IDA PAPER P-3016

INDEPENDENT REVIEW OF THE DEVELOPMENT  
RISKS ASSOCIATED WITH THE COMANCHE  
ARMED RECONNAISSANCE HELICOPTER

August 1994

# EXISTING CONTRACTED DEVELOPMENT PROGRAM

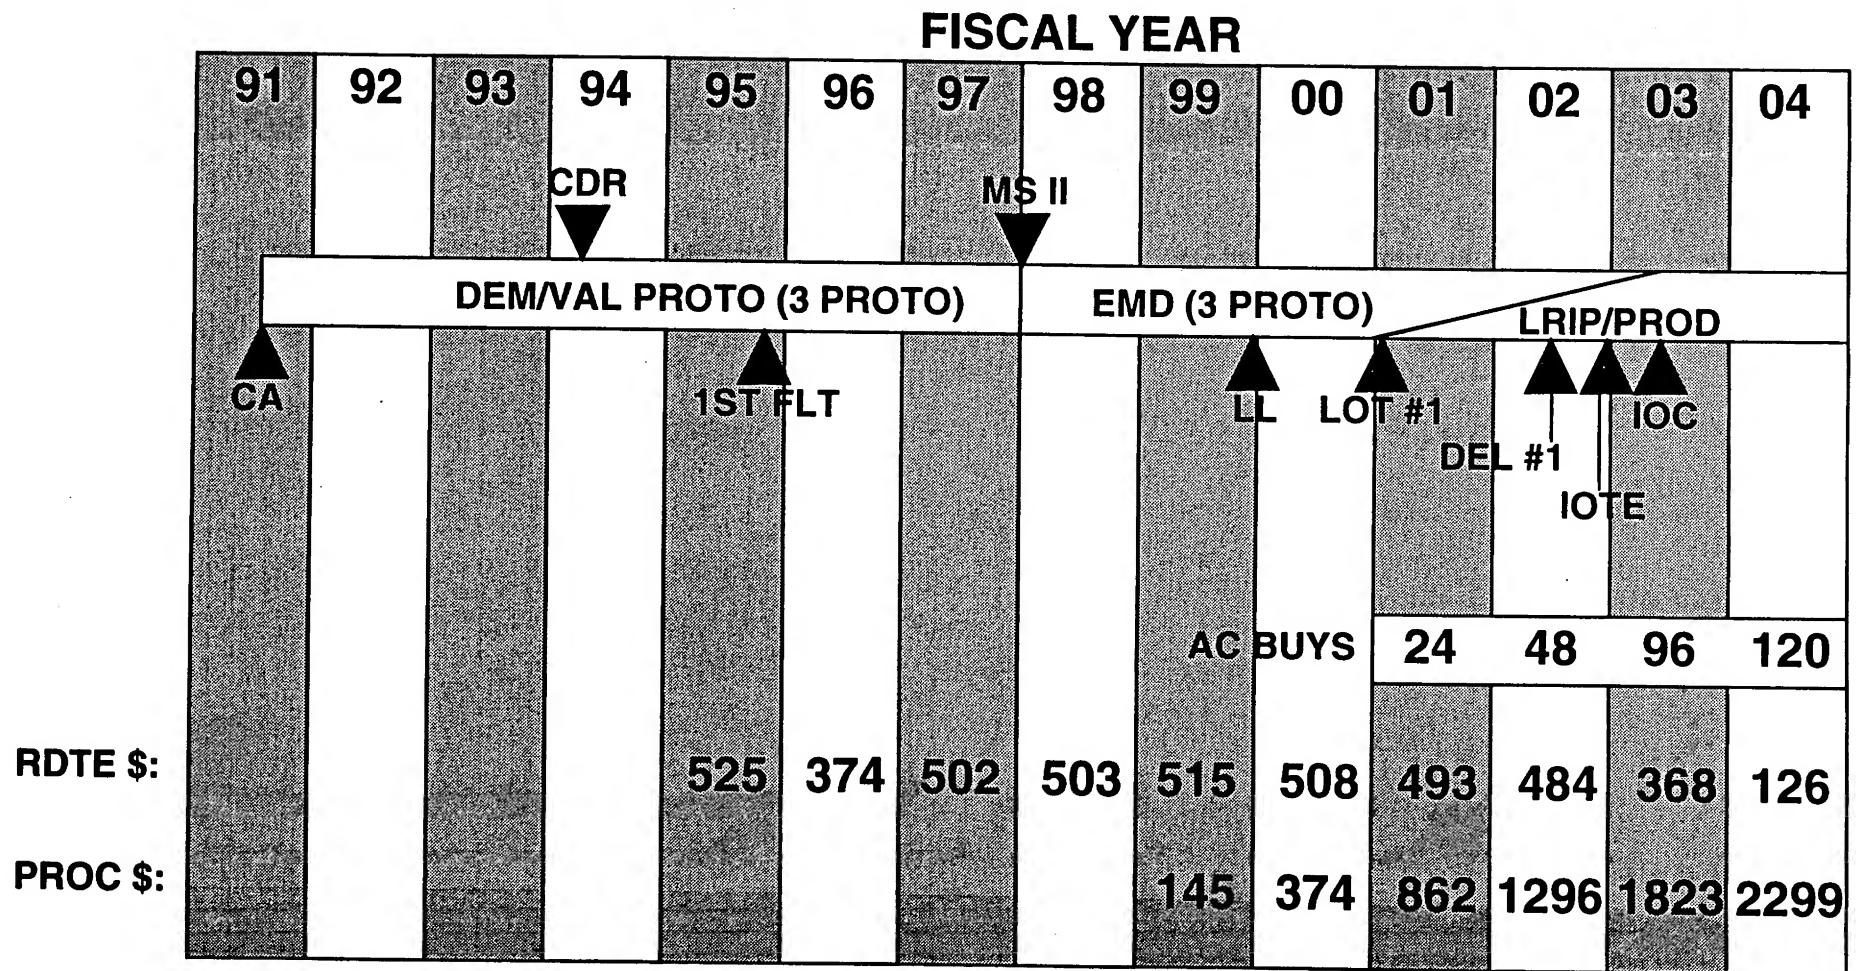
This chart shows the schedule and funding profile for the existing, contracted COMANCHE development program. Actually, only the DEM/VAL phase is currently under contract. If this development plan were continued, the Army's COMANCHE Program Office and the Boeing-Sikorsky Joint Program would soon need to begin negotiating a contract for the EMD phase of development.

As indicated on the schedule, this program features three prototype aircraft built and tested during the DEM/VAL phase, with first flight of the first COMANCHE prototype scheduled for November 1995. Three additional prototypes would be built and tested during the EMD phase. At the conclusion of DEM/VAL and prior to the award of the EMD contract, a Milestone II review would be held for the program. Long-lead production would begin at the end of FY 1999 and the first 24 production aircraft would be funded in FY 2001. Plans call for production to ramp up to 48 in FY 2002, to 96 in FY 2003, and to the full production rate of 120 per year by FY 2004. The first production aircraft would be delivered to the Army in mid FY 2002. The Initial Operational Test and Evaluation (IOTE) would be held early in FY 2003. Initial Operating Capability would be achieved by mid FY 2003.

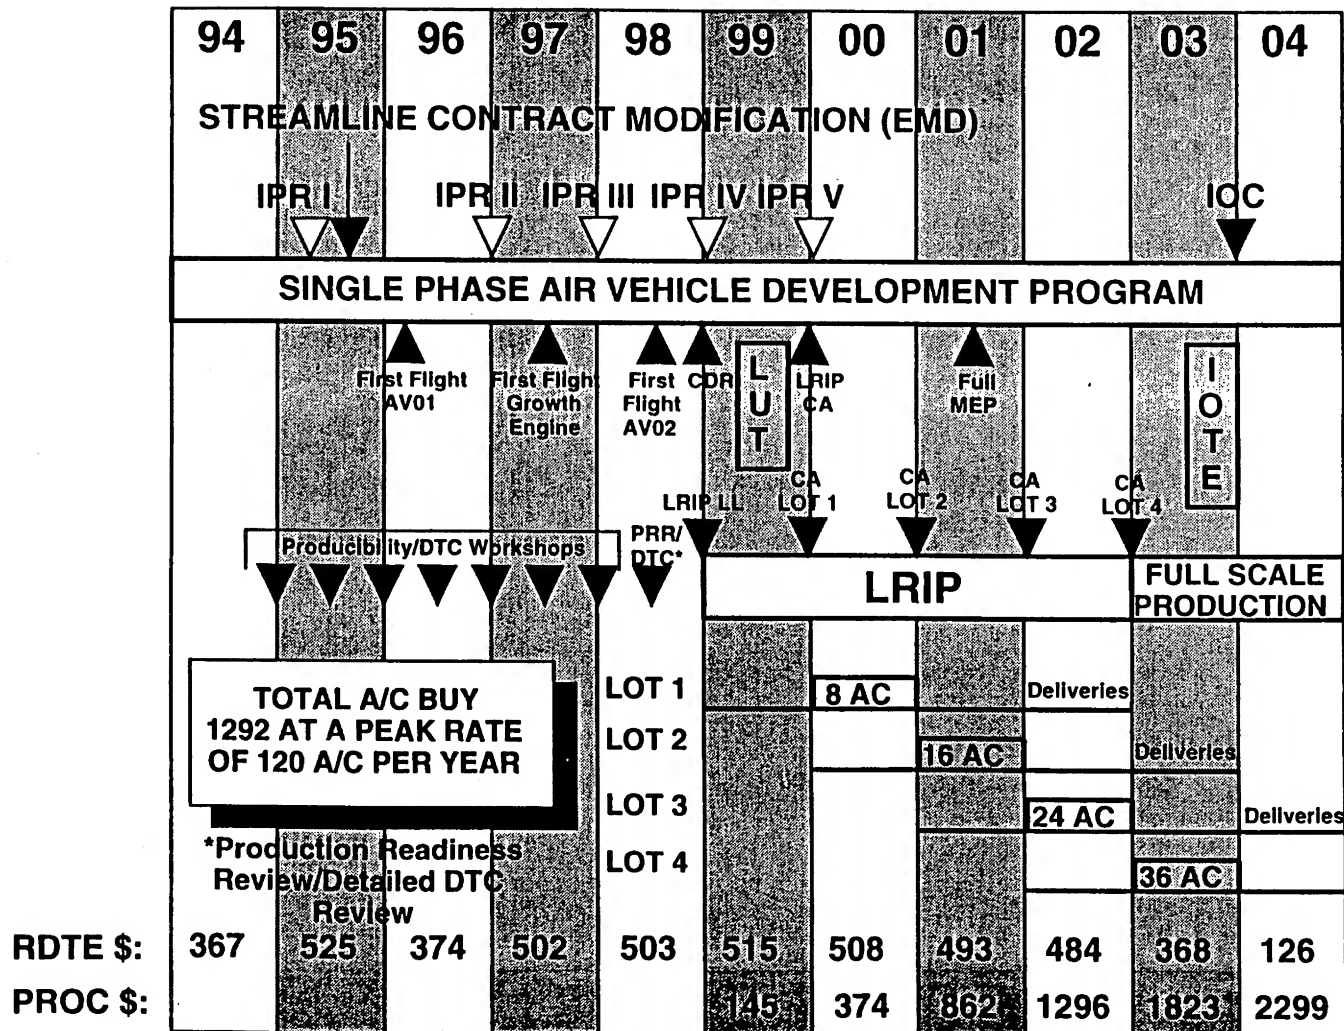
The schedule for the "streamlined" development program proposed by the Army is shown on this chart. Under this plan, in May 1995 the Army would modify the existing COMANCHE development contract to incorporate the activities normally conducted during EMD into a new single-phase development program. The first flight of the first of two DEM/VAL prototypes would occur in early FY 1996, several months later than was proposed under the existing development contract. The first flight of the second DEM/VAL prototype would not occur until late FY 1998, nearly 2 1/2 years after the first flight of the first prototype. The next three prototypes would be taken from the first lot of eight Low-Rate Initial Production (LRIP) aircraft. These prototypes would be delivered to the Army during FY 2002.

In comparison to the Army's previous plan for COMANCHE development, the "streamlined" plan initiates production one year earlier, but at a significantly slower rate. In the first year (FY 2000), only 8 aircraft would be built; in the second, 16 aircraft; in the third, 24 aircraft; and in the fourth (FY 2003), 36 aircraft.

OSD oversight for this program would be accomplished through a series of In-Process Reviews (IPRs), the first of which would occur early in FY 1995 prior to the award of the modified development contract. Beginning at the end of FY 1996, in-process reviews would

# REVISED STREAMLINED PROGRAM

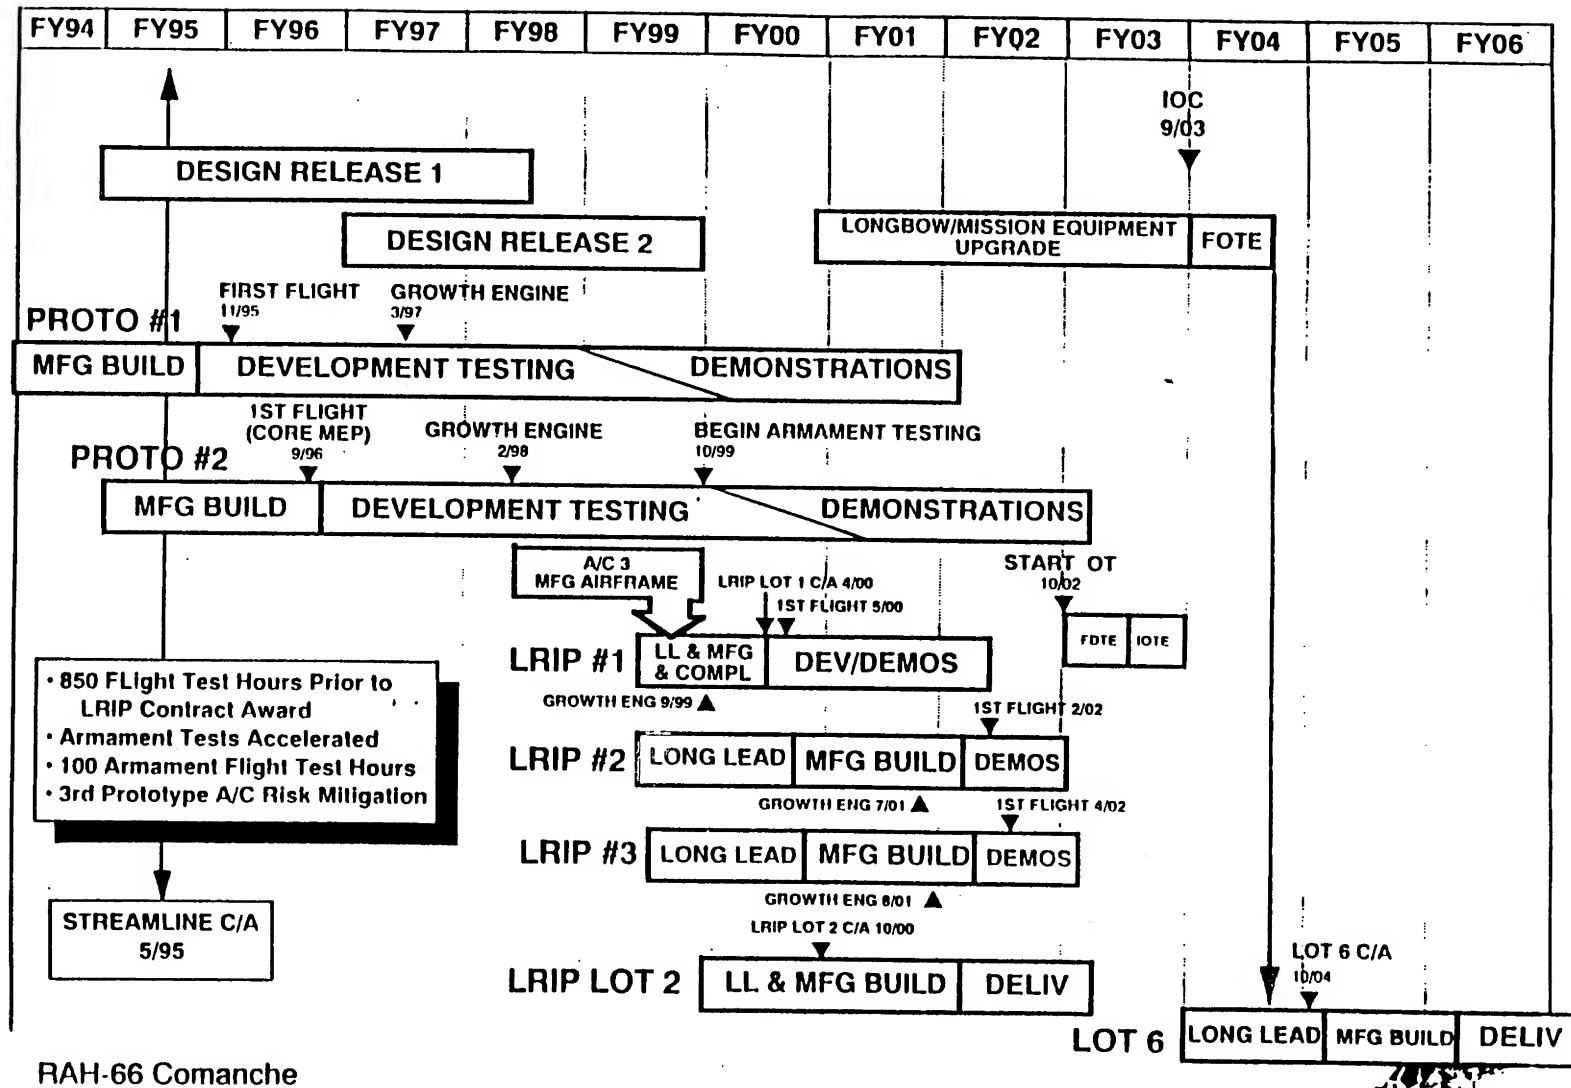
Following the submission of its original "streamlined" proposal, the Army's COMANCHE Program Office significantly revised its approach, in large part to remedy deficiencies identified during the OSD review of the plan as well as objections raised in other critiques, including that of this panel. This chart shows the revised "streamlined" program as briefed to the review panel on August 18, 1994. Relative to the initial "streamlined" approach, the revised approach features a number of significant changes of which the principal alterations are summarized on the next two charts.
